WORK INSPECTION REQUEST (WIR) FORM

Contractor:	HAIF-FREYSSINET JV
Project:	RA2RC
Contract No.:	QPMO-410-CT-00618
Work Inspection Request Number:	QRXM114000-HFC-TEC-WIR-ITS-02-RO5-00090

Inspection request for Installation of Traffic signal Gantry (Cantilever), Junction-2 (13 mtr) , Junction-3 (12 mtr) and Junction-3 (16 mtr), at Access to Resort core interim Road. As per attached drawing.

Project Name: Package 3 - Interim Road Access to Resort Core	**Project Code:** QRXM114000
**Location: RA2RC ** Qiddiya INTERM ROAD	**Date:** 13-June-2026
Document Title: Method of Statement for Traffic Signal System Installation and Commissioning	Ref No: QRXM114000-HFC-TEC-MST-ITS-02-RO5-00002
	Rev No: 00

Drawing title:
SHOPDRAWING OF TRAFFIC SIGNAL SYSTEM FOR JUNCTION-2
TYPICAL DETAILS+GPS RADIO UNIT ON 3.7m TRAFFIC SIGNAL POLE

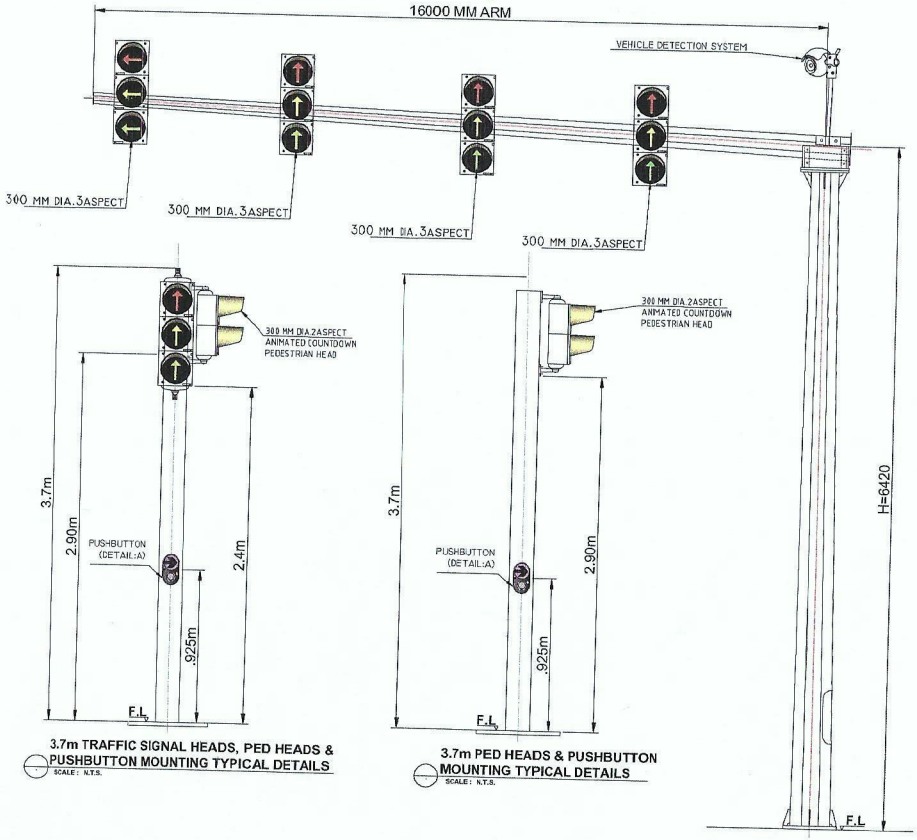
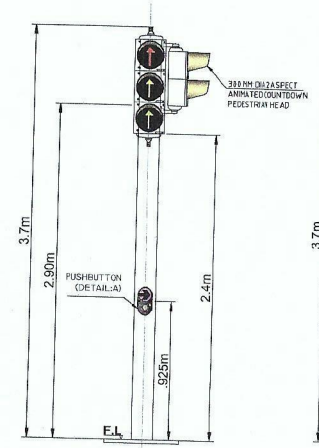
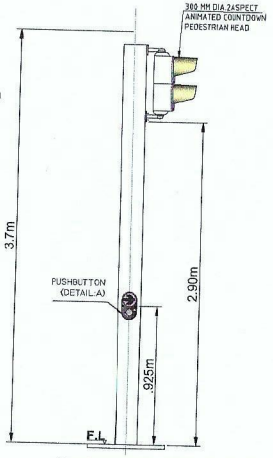
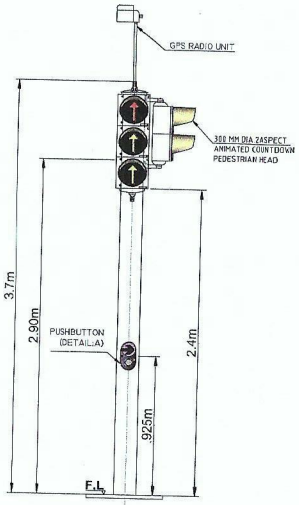
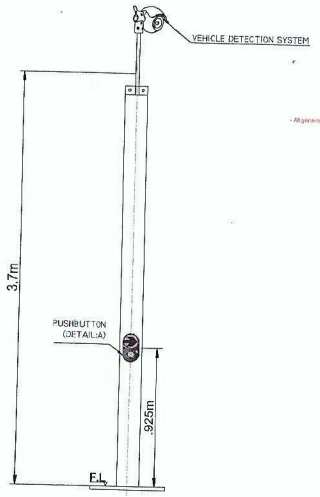
installed one piece at junction 2 steel Gantry 13m

For comments refer to the drawing # QRXM114000-HFC-DRW-SDW-ITS-02-R05-00024

All general comments stated on drawing and previous Rev. shall considered.

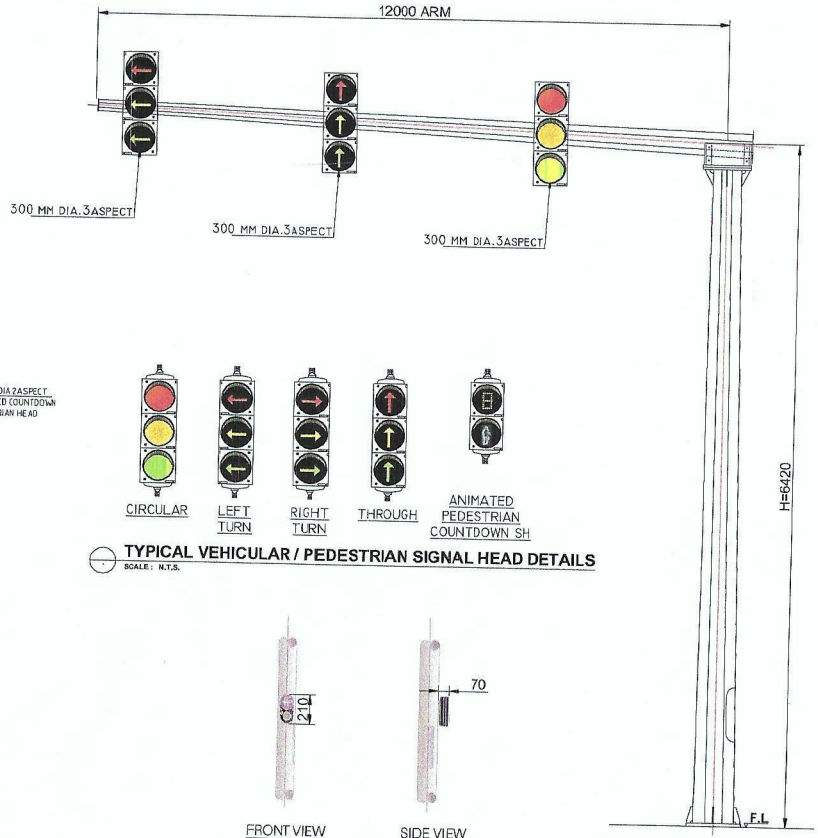
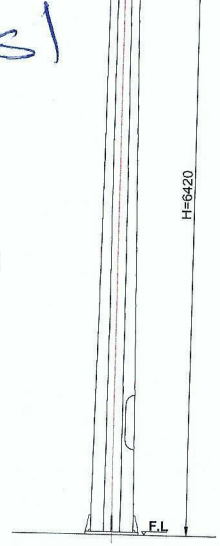
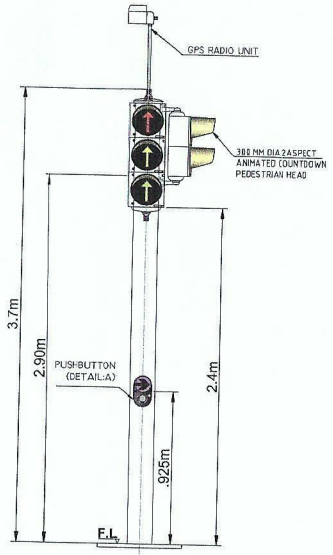
16m Gantry installed at junction 3

For comments refer to the drawing # QRXM114000-HFC-DRW-SDW-ITS-02-RO5-00033

Drawing title:
SHOPDRAWING OF TRAFFIC SIGNAL SYSTEM FOR JUNCTION-3
TYPICAL DETAILS-2+GPS RADIO UNIT ON 3.7m TRAFFIC SIGNAL POLE

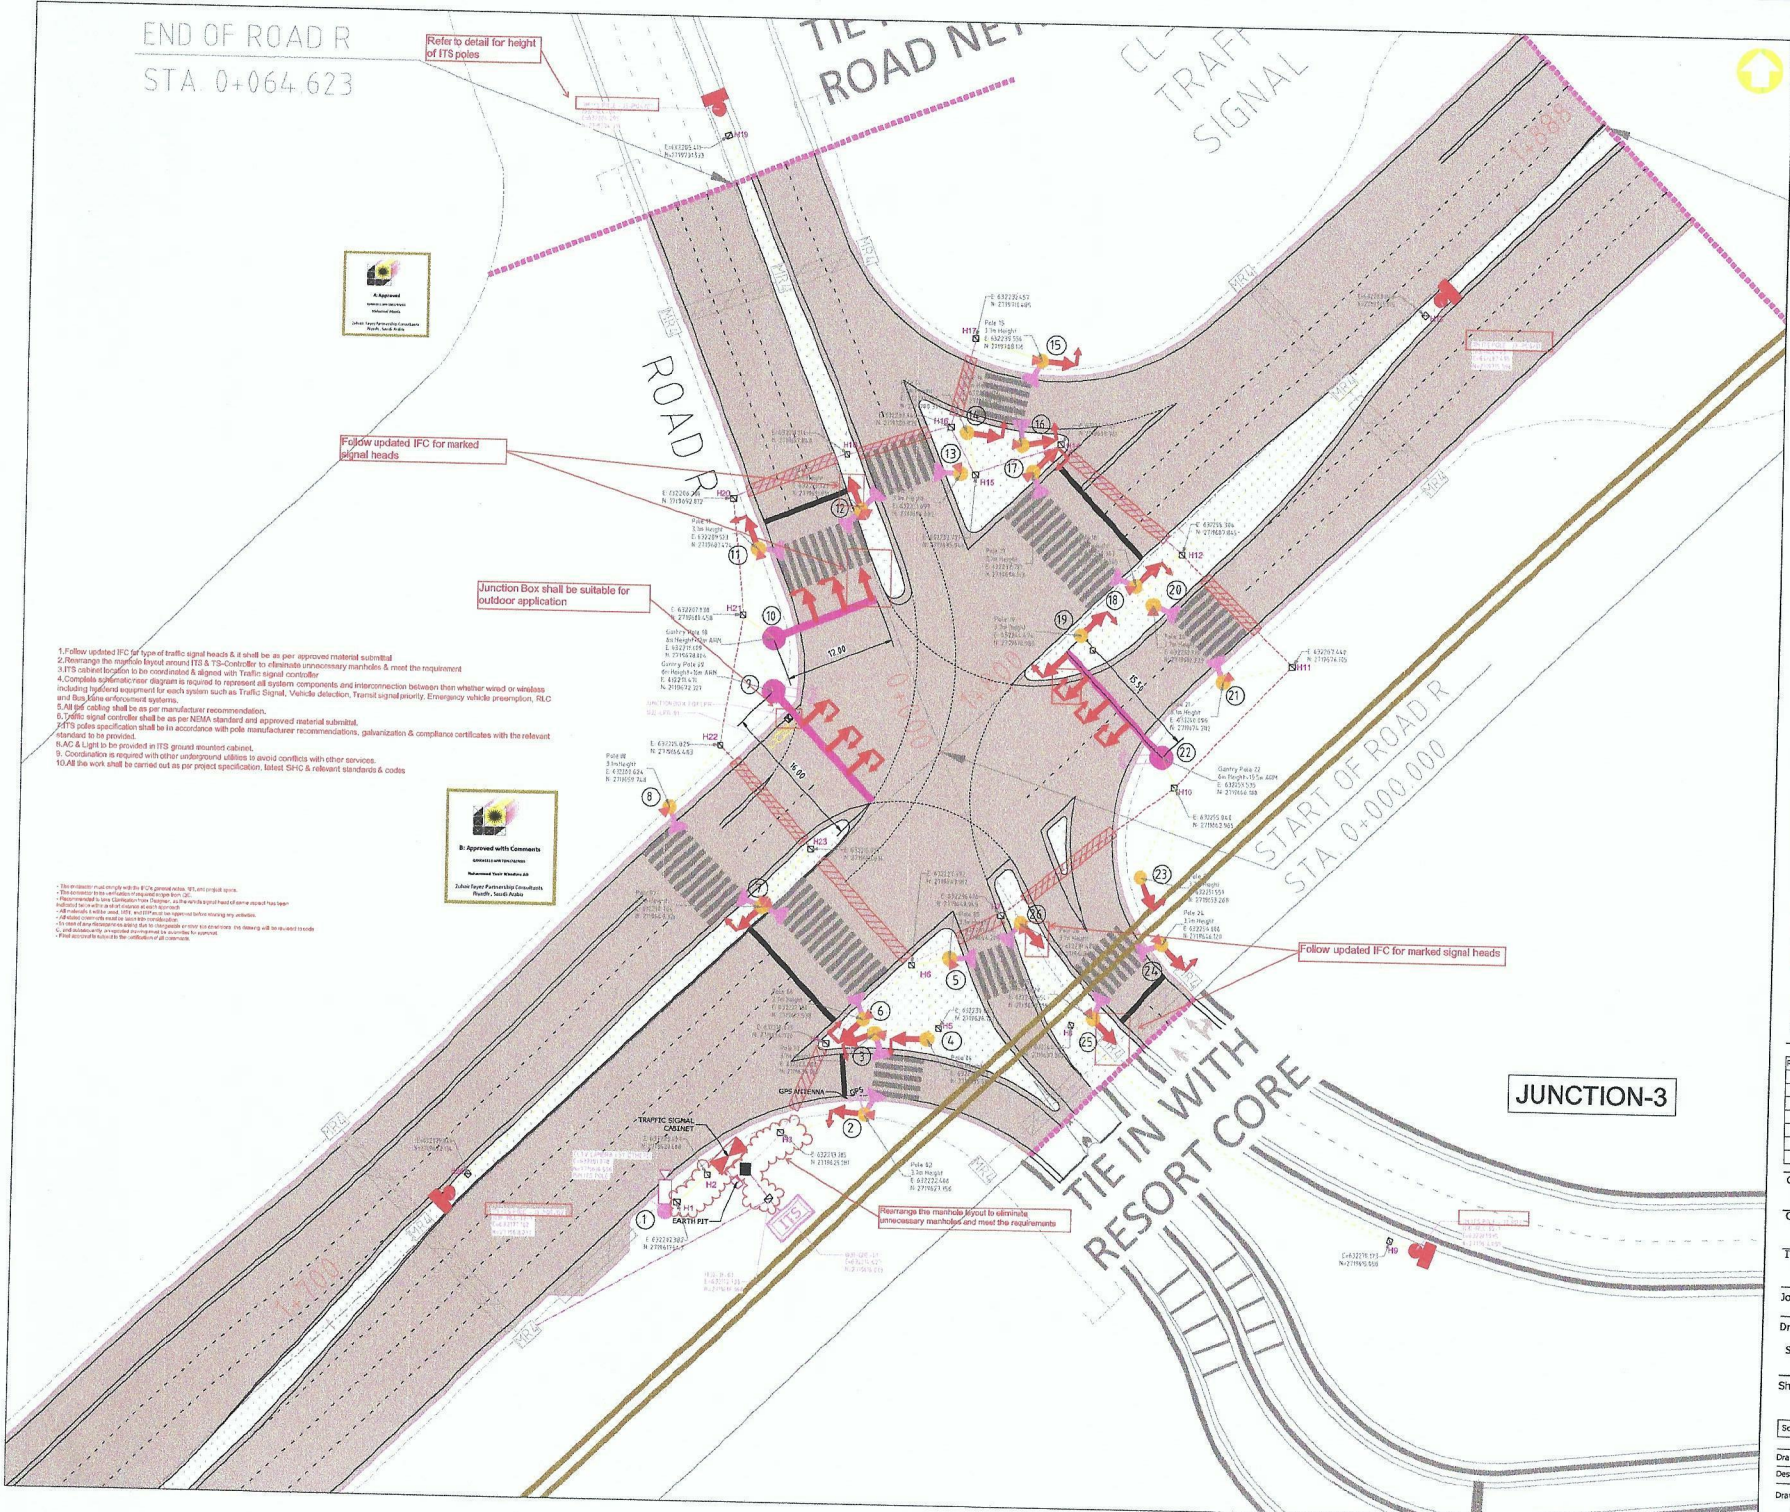
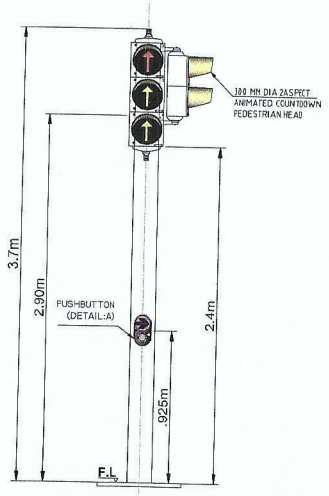
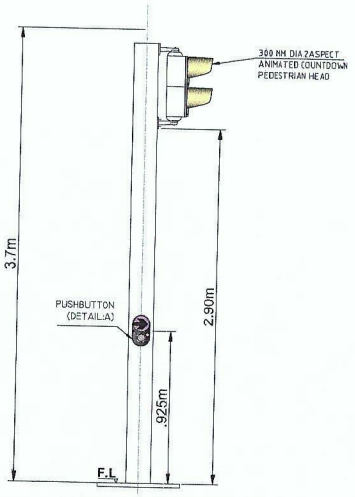
12m Gantry installed at Junction 3

Drawing title: Shopdrawing Foundations of Traffic Pole 6.42m with Cantilever Arm at Junction 2 & 3

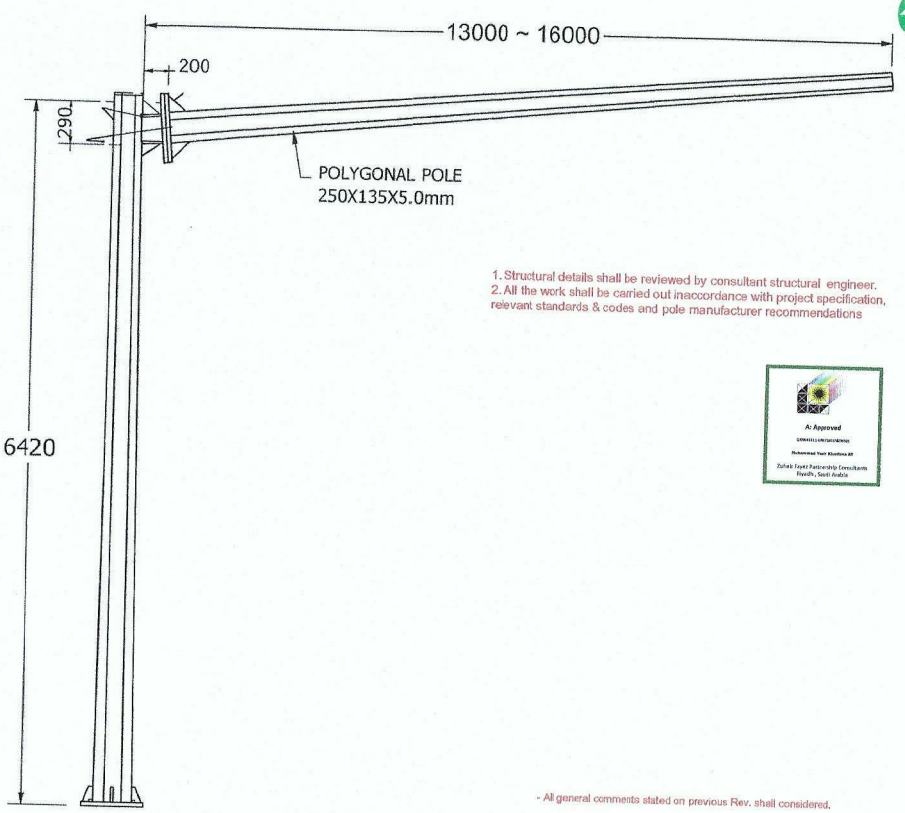
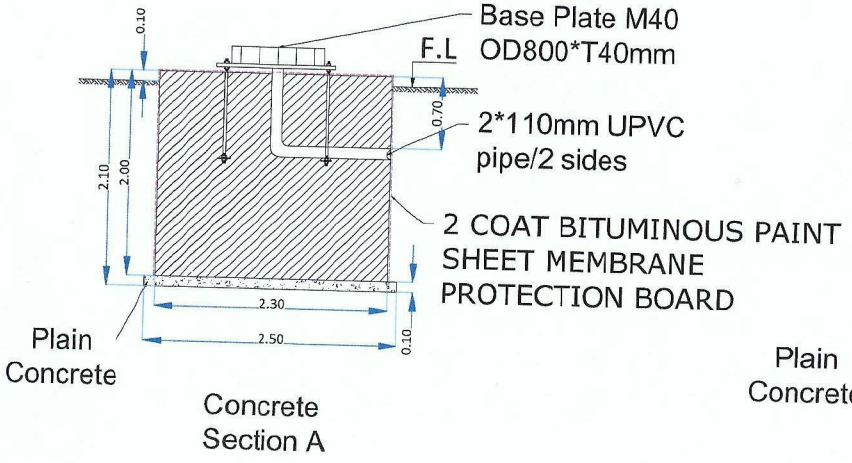
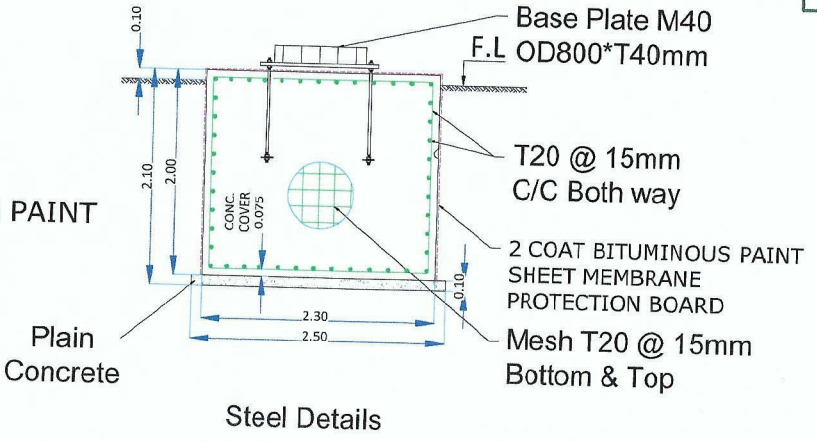
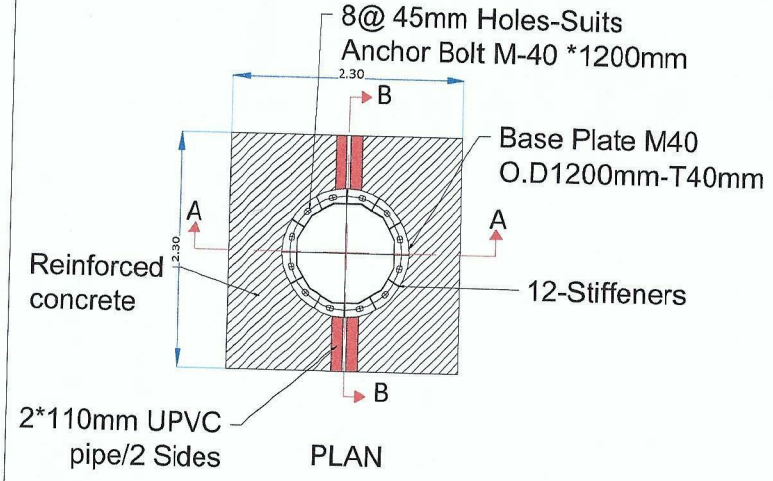
1. Structural details shall be reviewed by consultant structural engineer.
2. All the work shall be carried out inaccordance with project specification, relevant standards & codes and pole manufacturer recommendations

- All general comments stated on previous Rev. shall considered.
